RE: Bid Title: Construction of Leon County Public Library Eastside Branch
Bid No: BC-06-08-10-33
Opening Date: Tuesday, June 8, 2010 at 2:00 PM

ADDENDUM #3

This letter serves as Addendum #3 for the above referenced project.

UPPER ROOF FRAMING PLAN
SCALE 1/8"=1'-0"

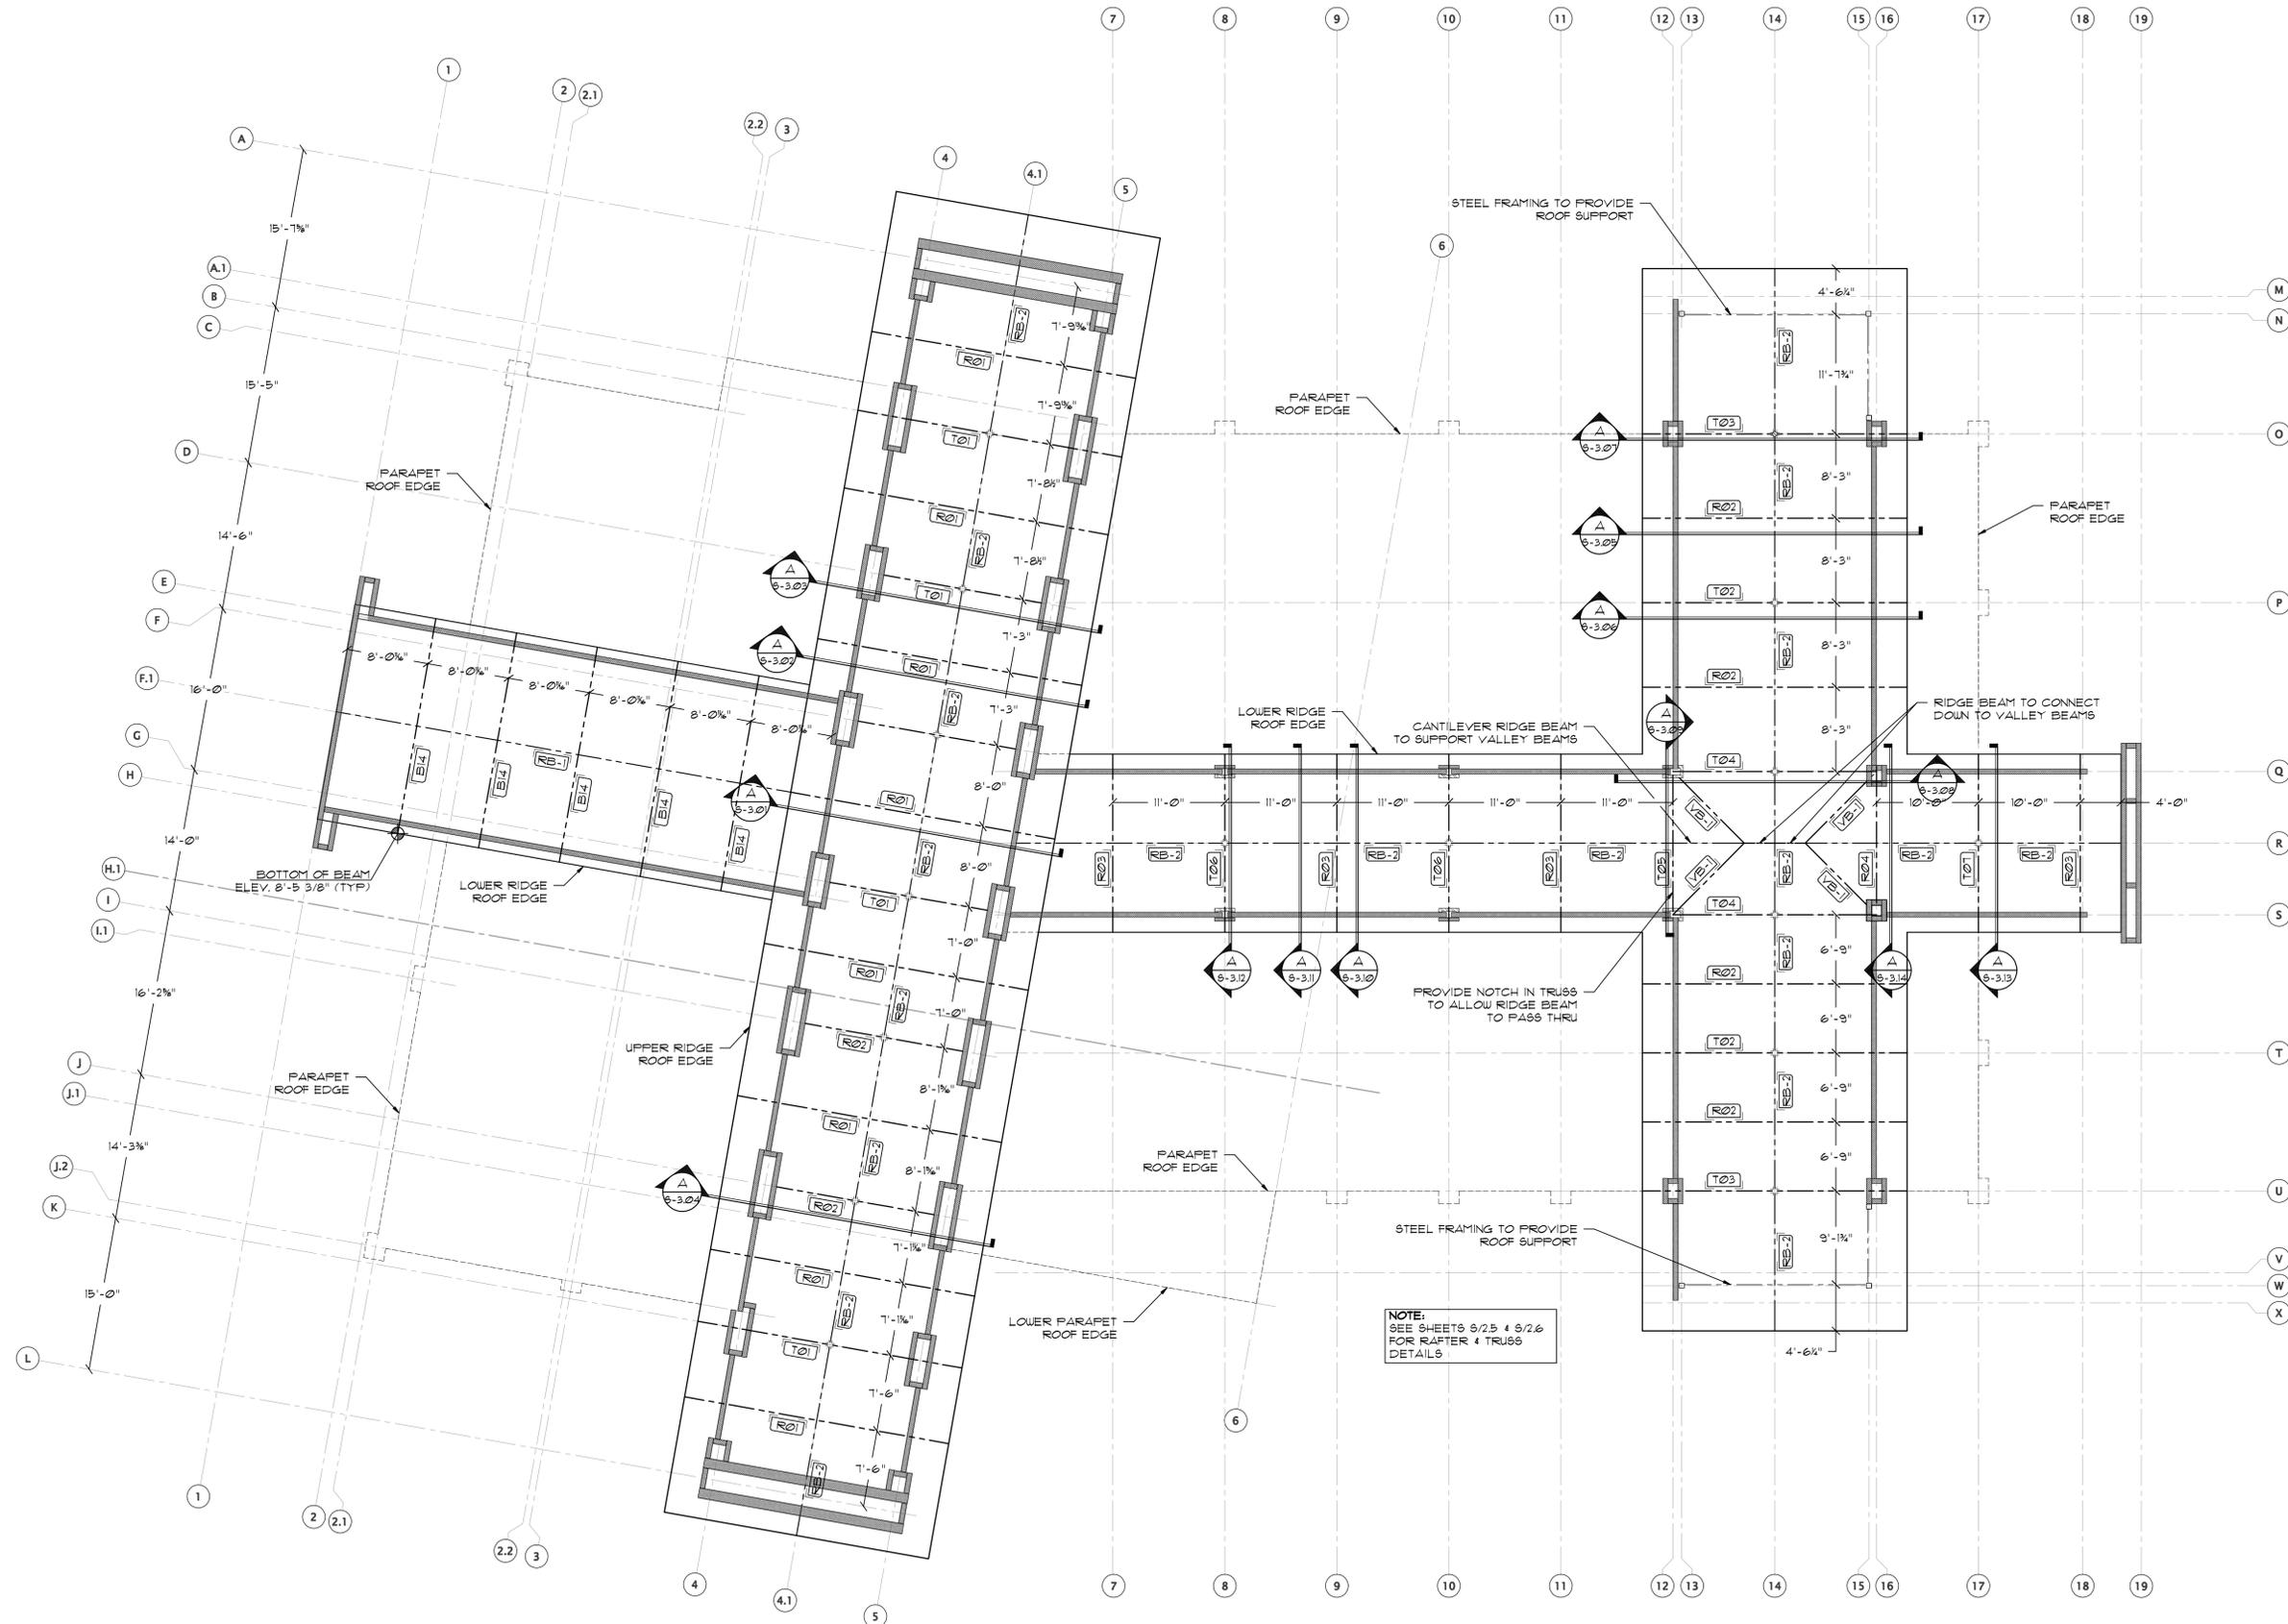
S1: *Reference Structural Sheet S-1.1.* – Column lines 3, 5, 9, 10, 11, 12, 13, 15 and 16 have been modified to show CP designations. See attachment.

S1: *Reference Structural Sheet S-1.1, S-1.2, S-1.3, S-1.4, S-1.5 & S-1.6.* – Drawing have been modified to shown the scale. See attachment.

L1.2-R

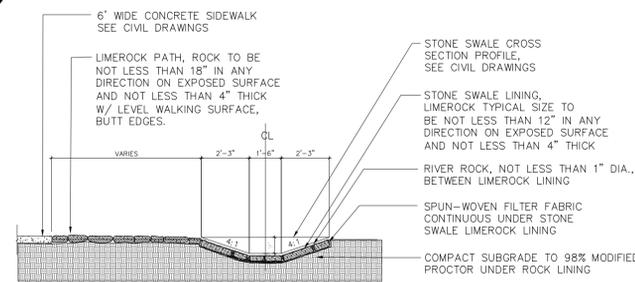
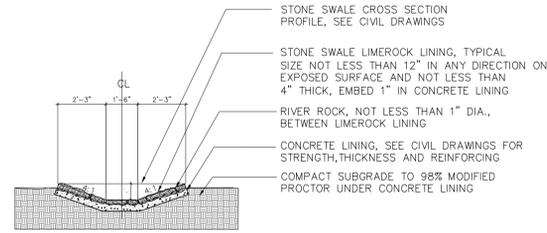
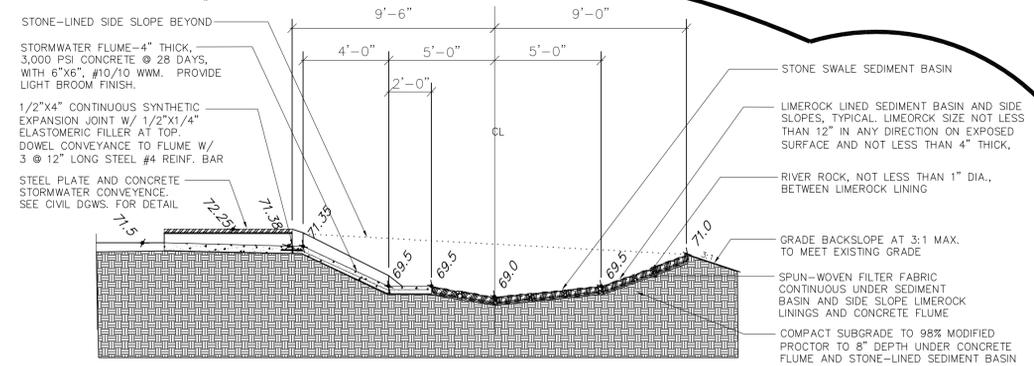
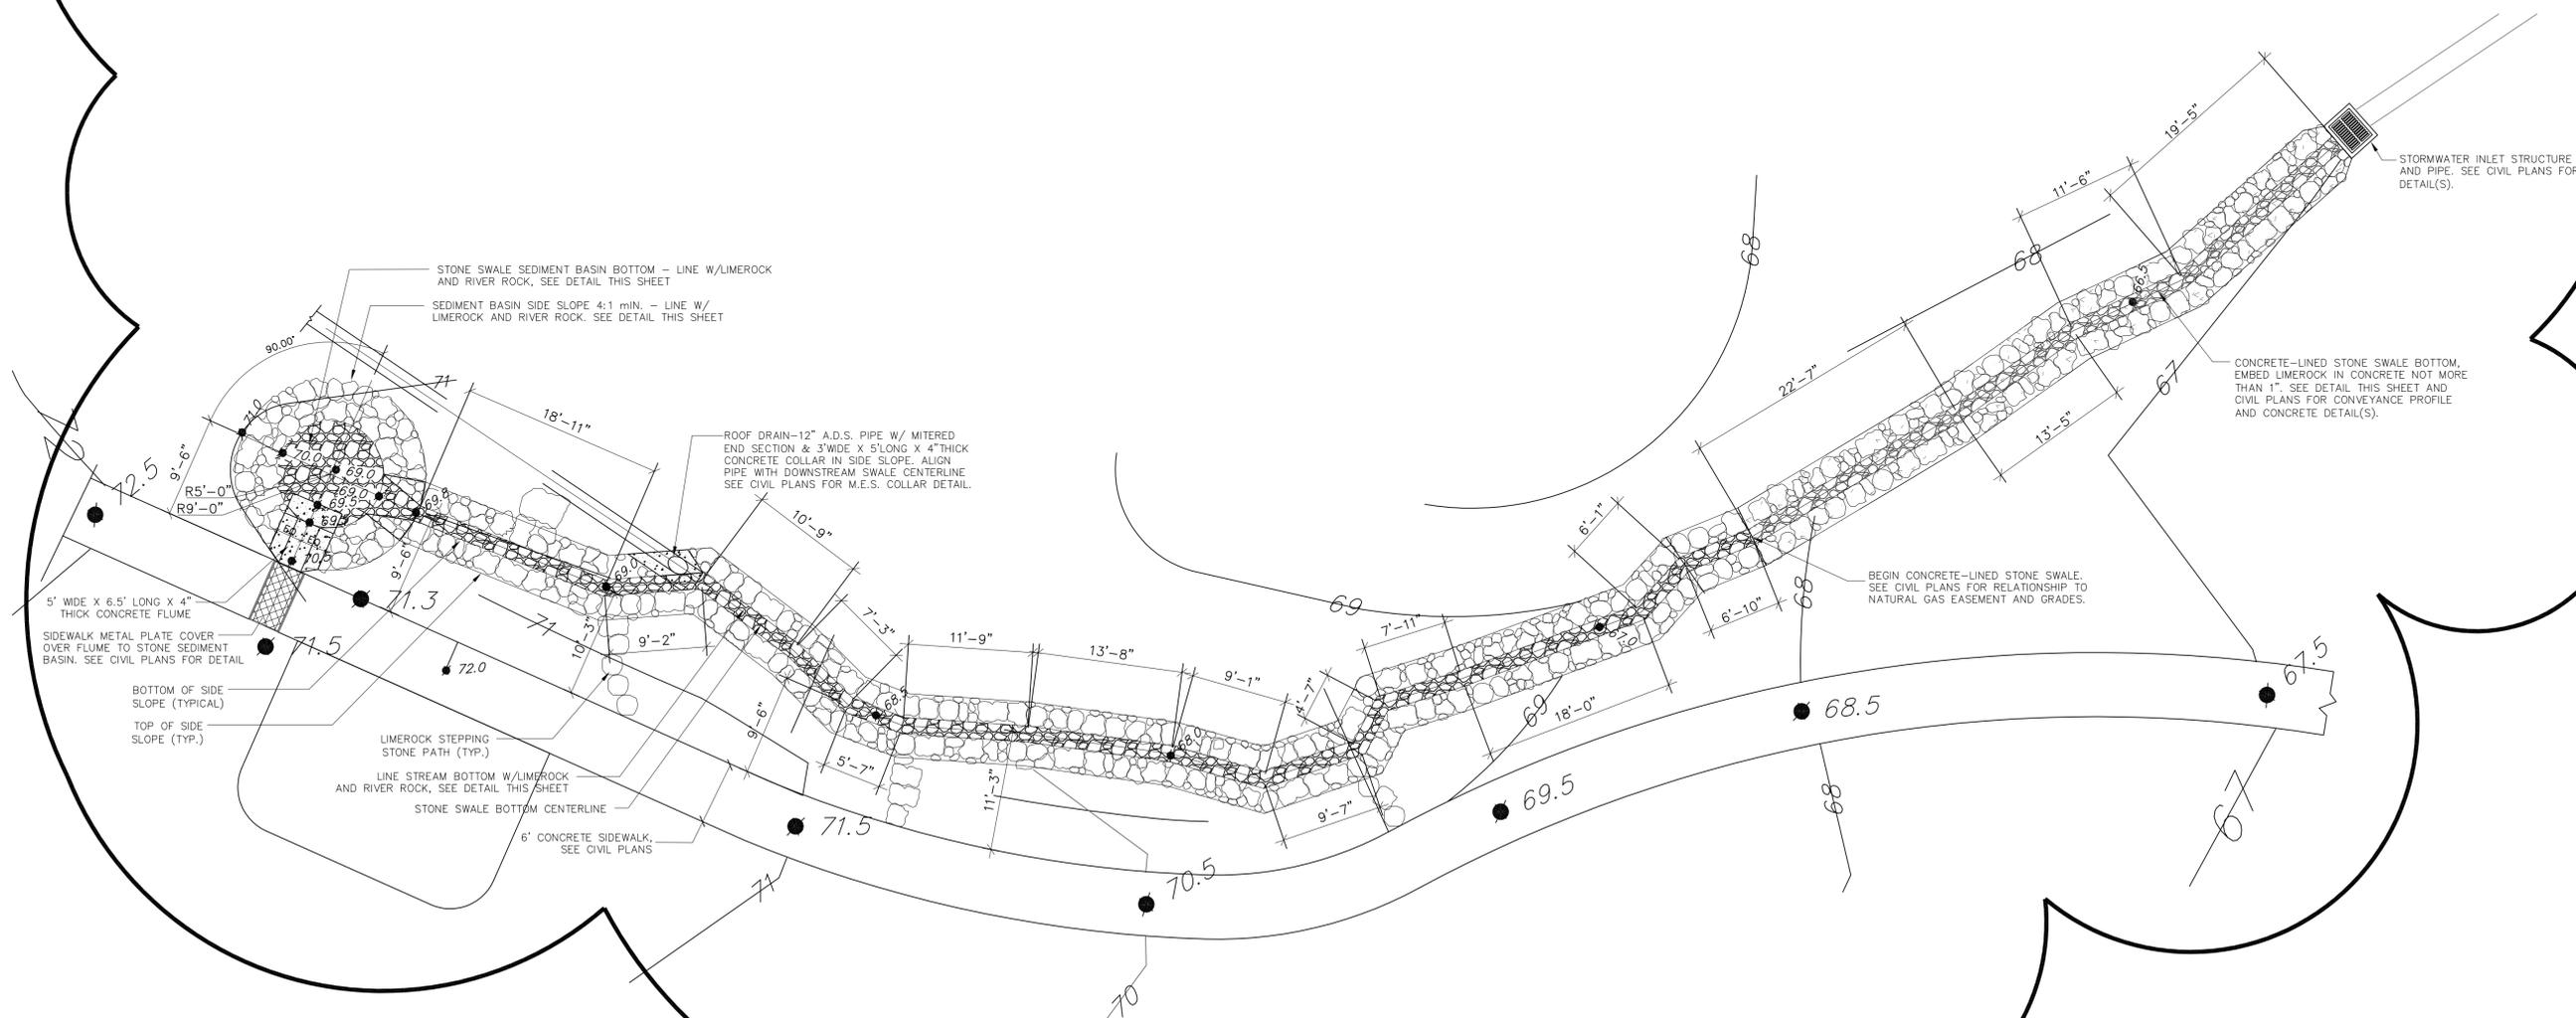
L2: *Reference Landscape Sheets L1.2 & L1.3.* – Landscape sheet have been added. See attachment.

L2.0-R

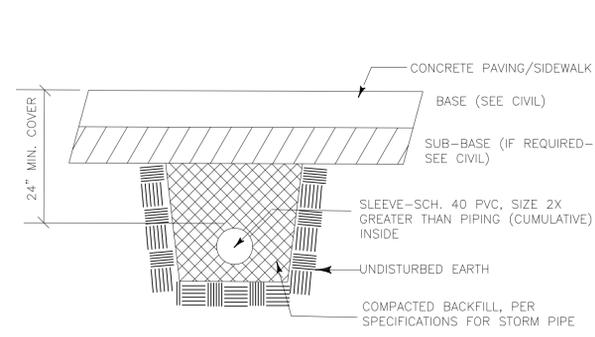
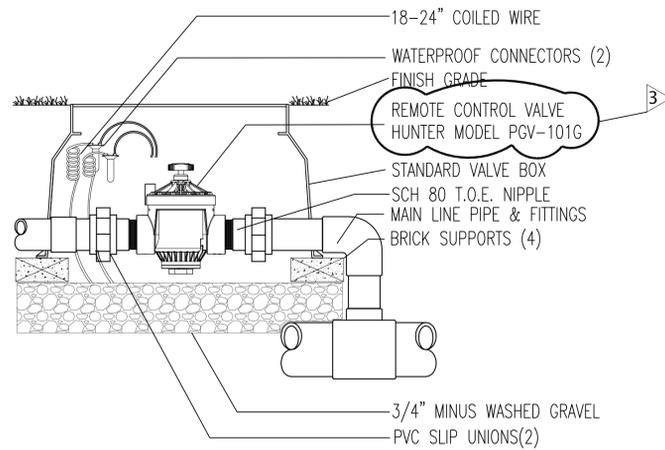
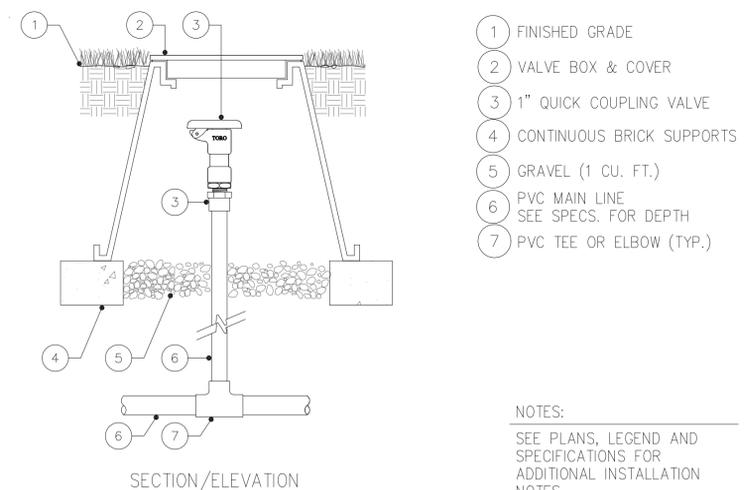
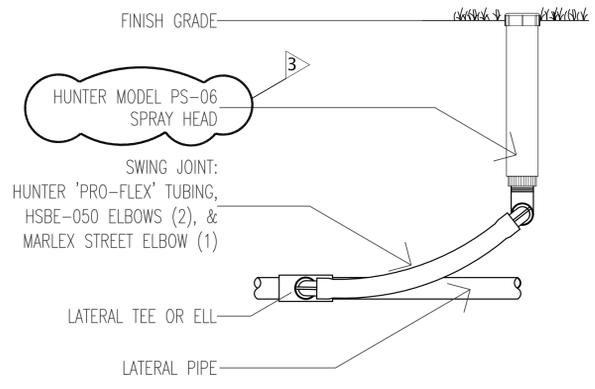
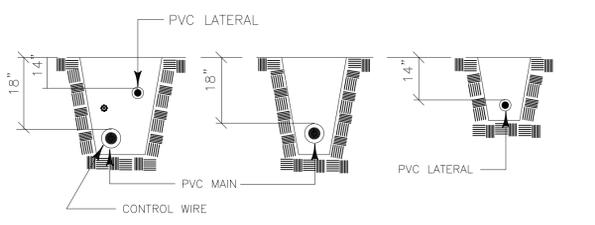
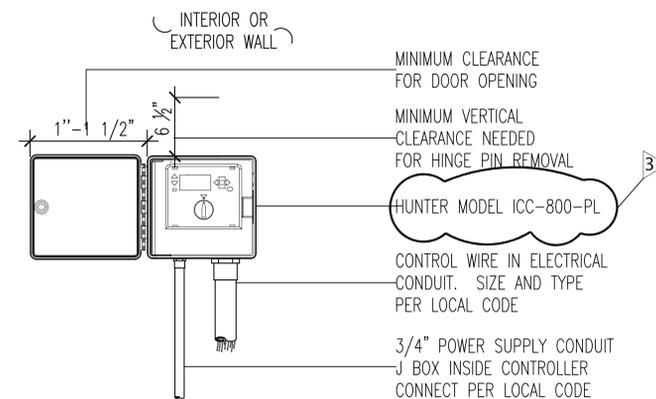
L1: *Reference Landscape Sheets L1.0, L1.1, L2.0 & L2.1.* – Modifications have been made on these sheets. See revision clouds. See Attachment.

E1.0

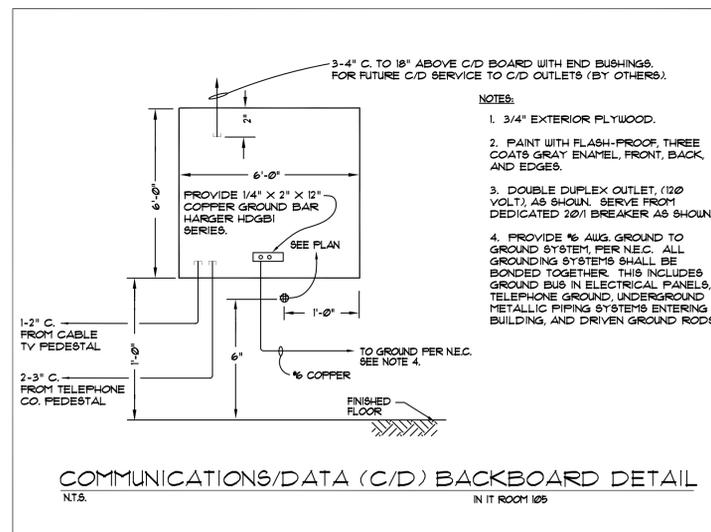
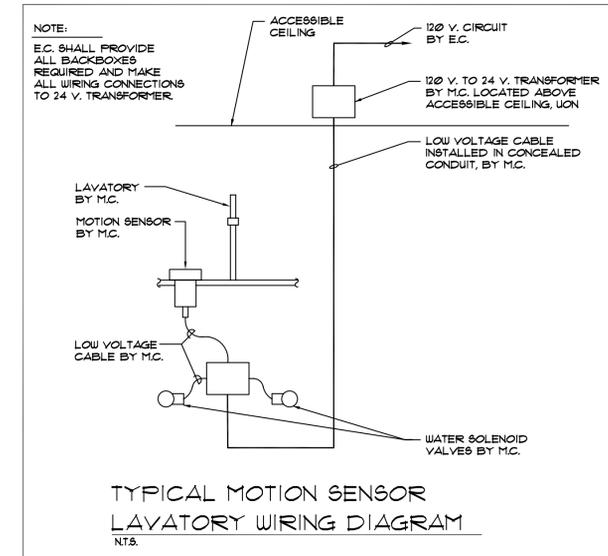
E1: *Reference Electrical Sheet E1.0.* – Lighting Fixture Schedule; Fixture F. Replace Sheet “E1.1” with “E1.2.” Add “ELECTRICAL NOTES” above “APPLICABLE ELECTRICAL CODES AND SPECIFICATIONS.” See attachment.
